Work Cell Door, F10123456

Work Cell Door, F10224316

Work Cell Door proposed design , door closed

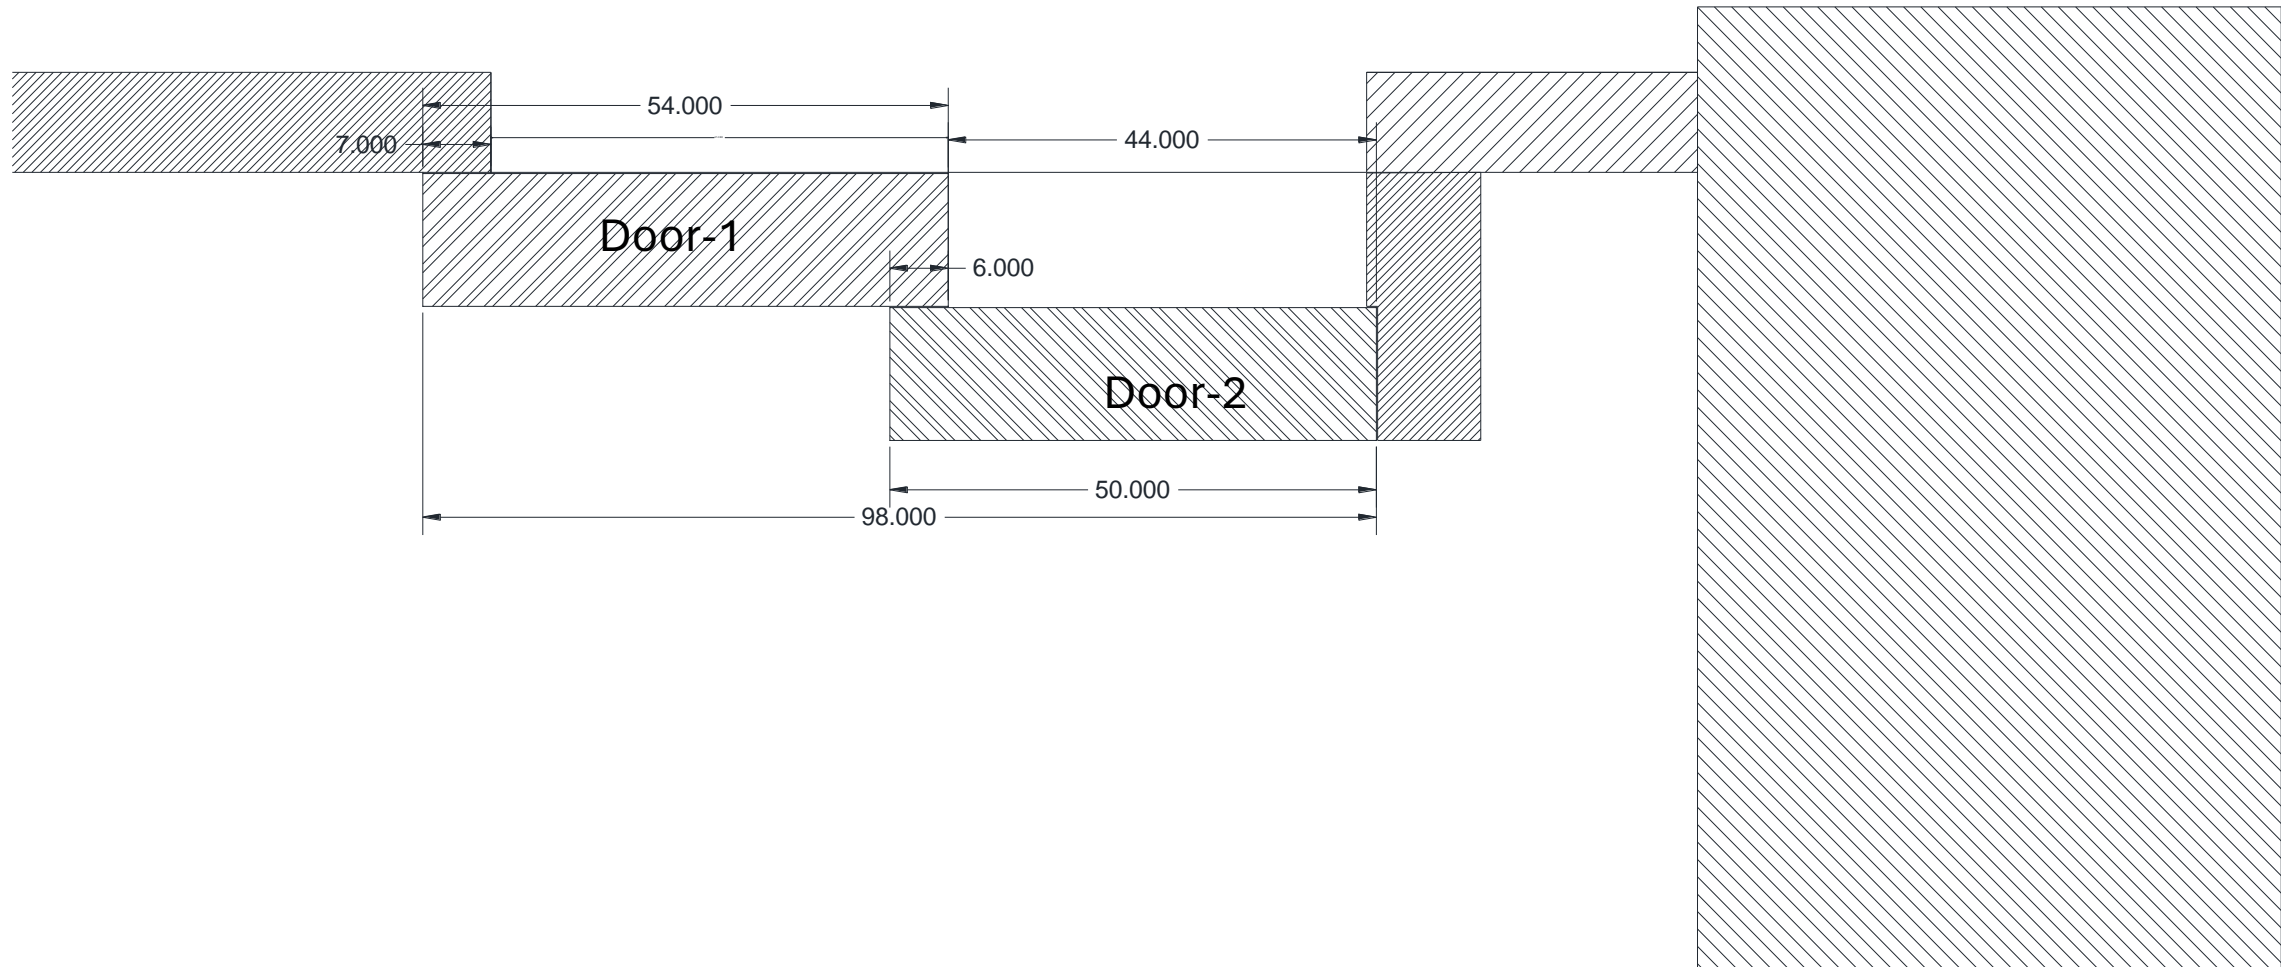
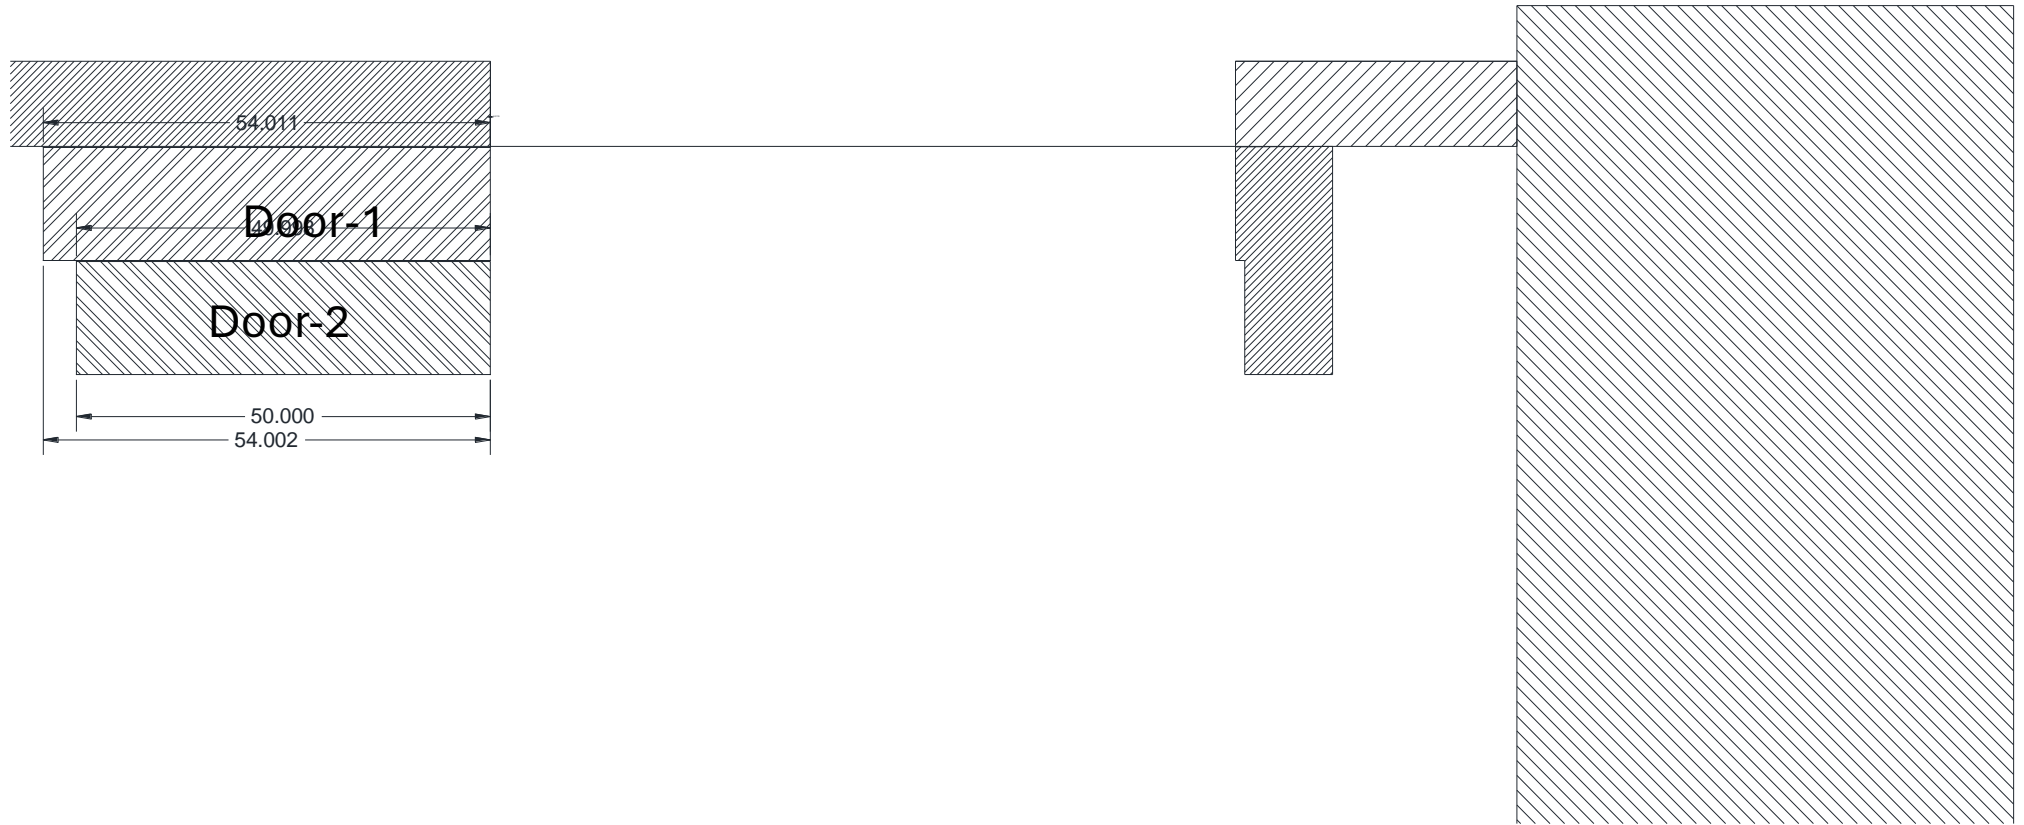
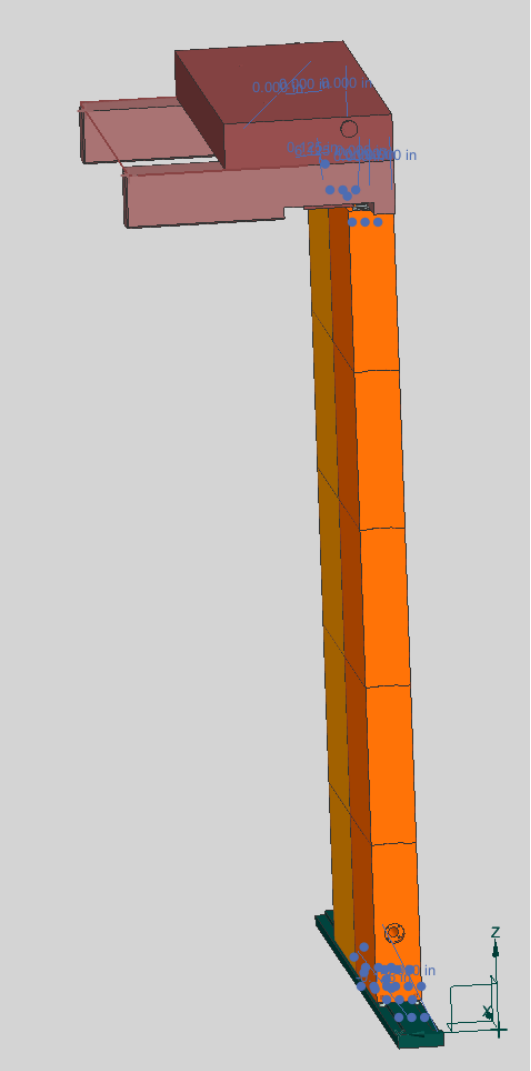
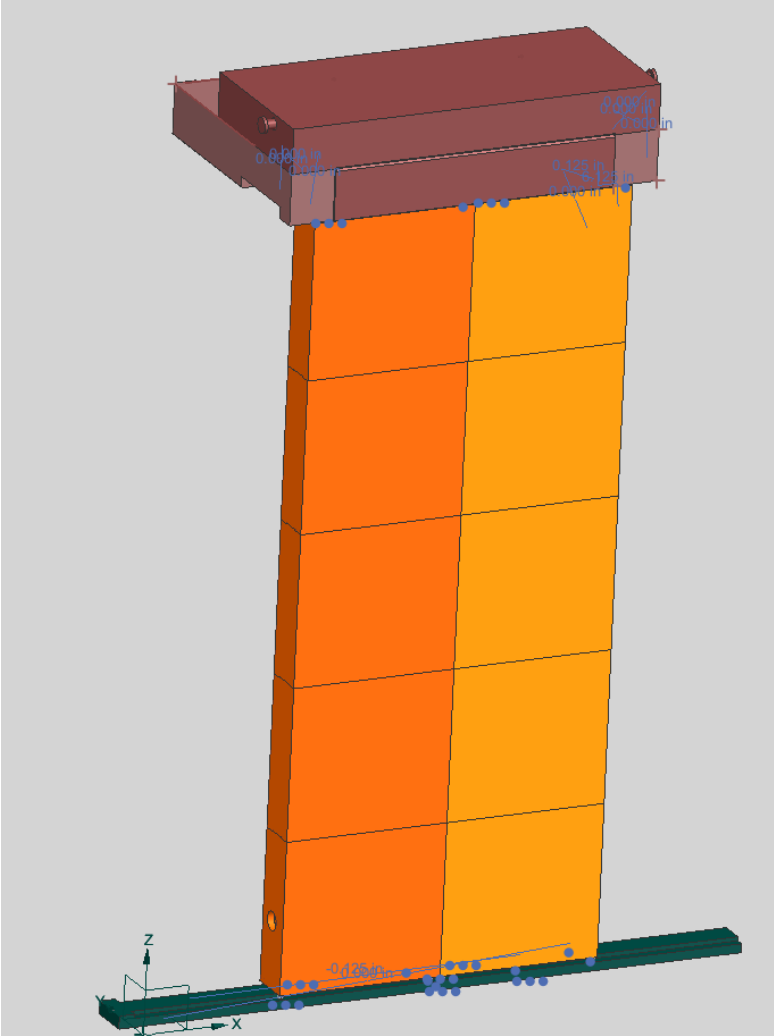
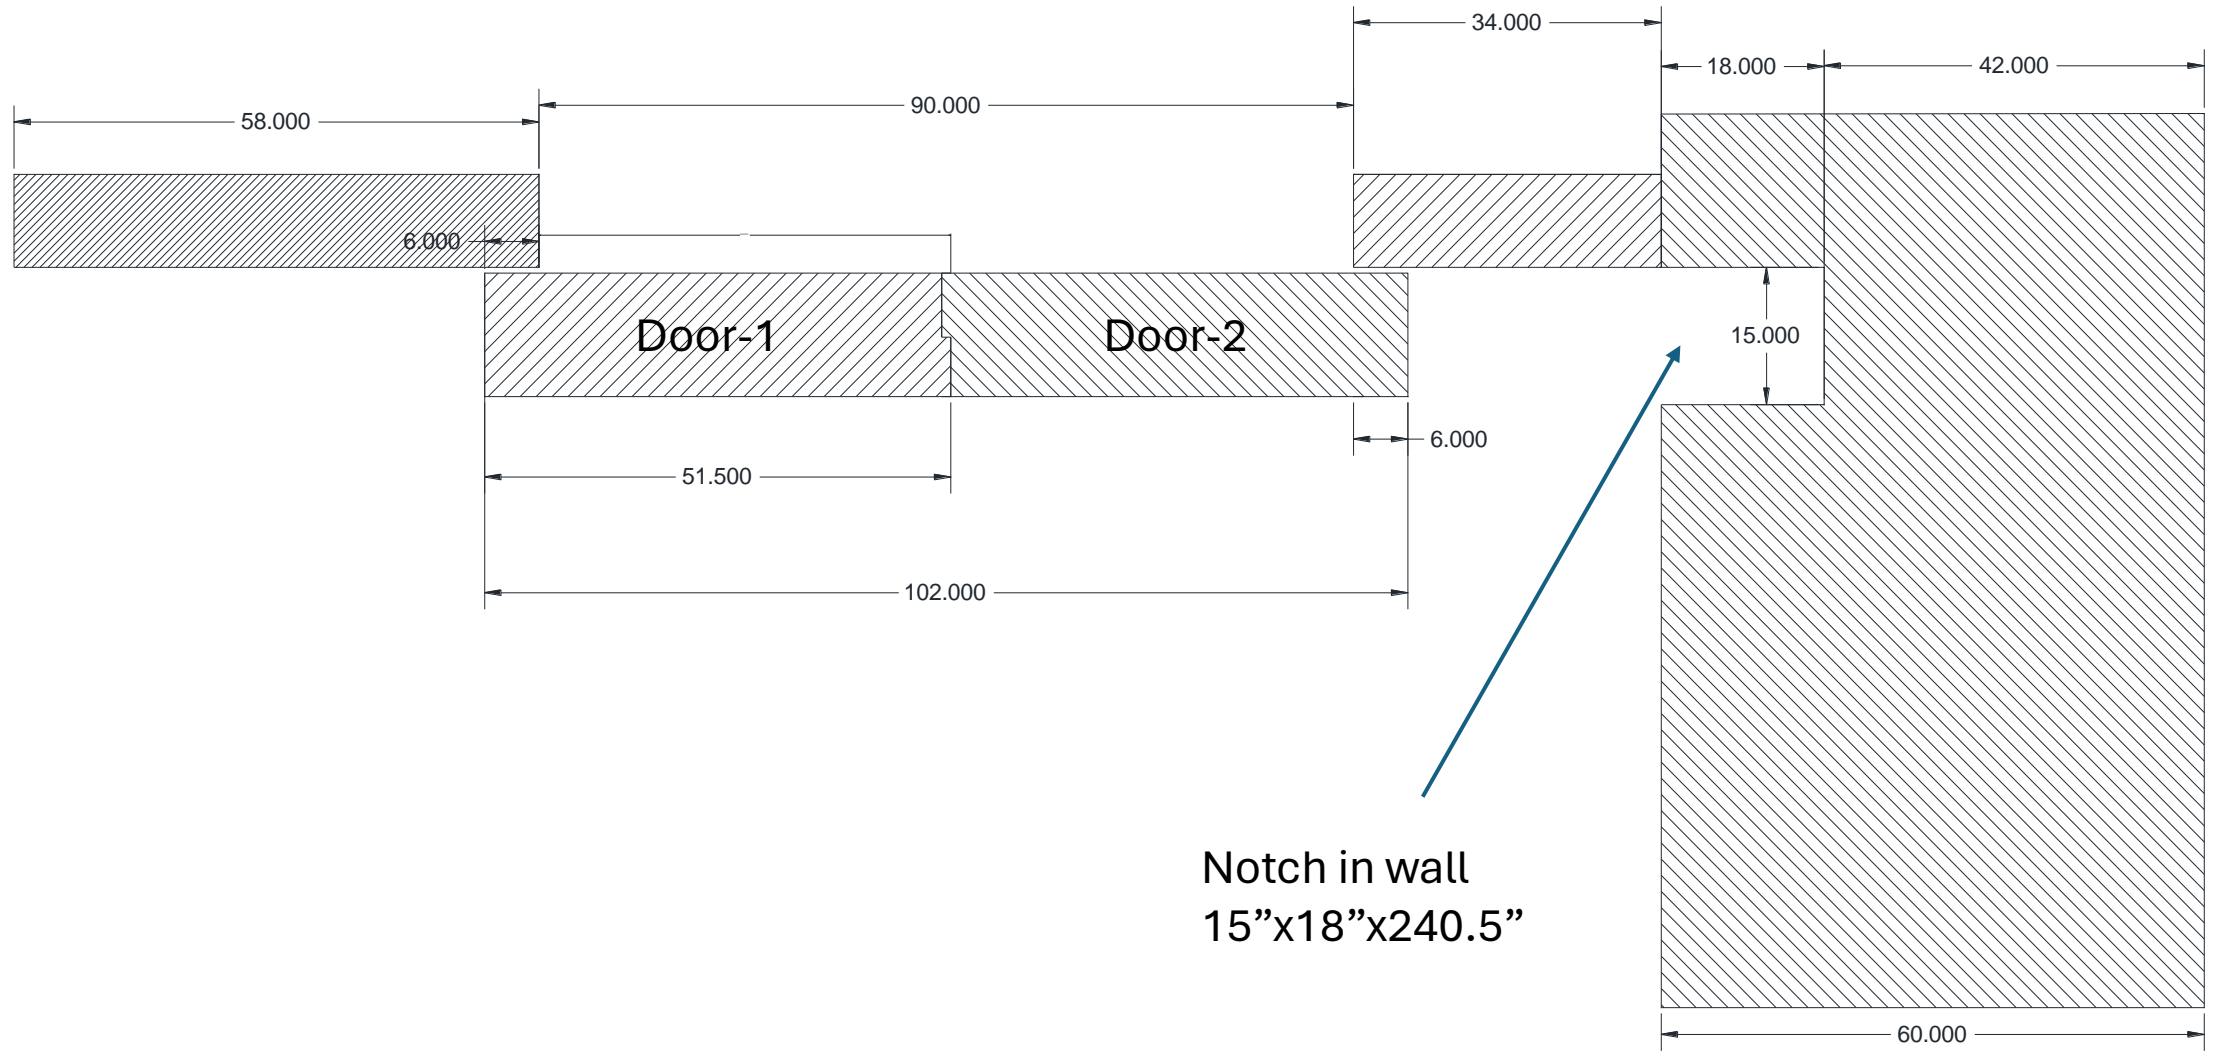
Work Cell Door current design , door closed

Work Cell Door current design , door opened

Work Cell Door proposed design , door opened
